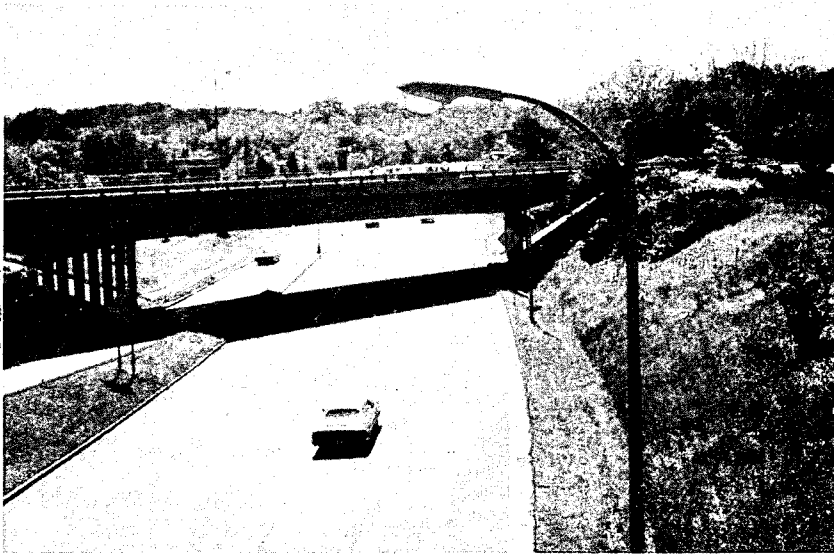
There is an opening and there is an end of the guardrail. Notice the skidmarks going into this area.

Mr. CRAMER. May I ask Mr. Prisk a question? Is there any regulation or standard with regard to six lanes going into four lanes and back to six lanes in an intersection area such as this?

Mr. CRAMER. I thought turnoffs were supposed to be outside the traveled roadway. Seemingly, this area ought to be outside the six lanes.

Mr. CRAMER. What would be the circumstance in this area that would justify closing in the four lanes?

Mr. CRAMER. There were not any buildings there, none to be condemned at any great value. How in the world can reducing the six lanes to four lanes be justified? I think it is obviously a traffic hazard the way it is built.

Now, does the Bureau have to approve that design?

Mr. PRISK. I know of no regulations. It is undesirable to have a lane drop.

Mr. PRISK. That is true. There are occasions, for one circumstance or another—

Mr. PRISK. One typical thing that happens is that failure to have sufficient right-of-way to permit opening up the pavement to the width—one possibility, of course, is difference in capacity, analysis, you do not figure that the traffic involved is going to be as heavy as it turns out to be.
